UN Regulation No. 129 (Enhanced Child Restraint Systems)

Proposal for draft Supplement 11 to the original version of UN Regulation No. 129 (Enhanced Child Restraint Systems)

Submitted by the expert from Spain*

Figure 3
Minimum distance for lateral impact

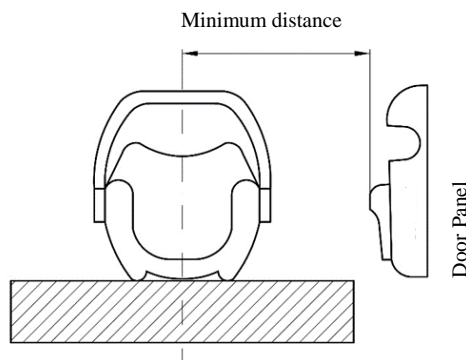
For each test, the initial position of the side impact door panel relative to the bench shall be adjusted according to the minimum distance between the vehicle's door panel and the centre of the seating position as shown in Figure 3.
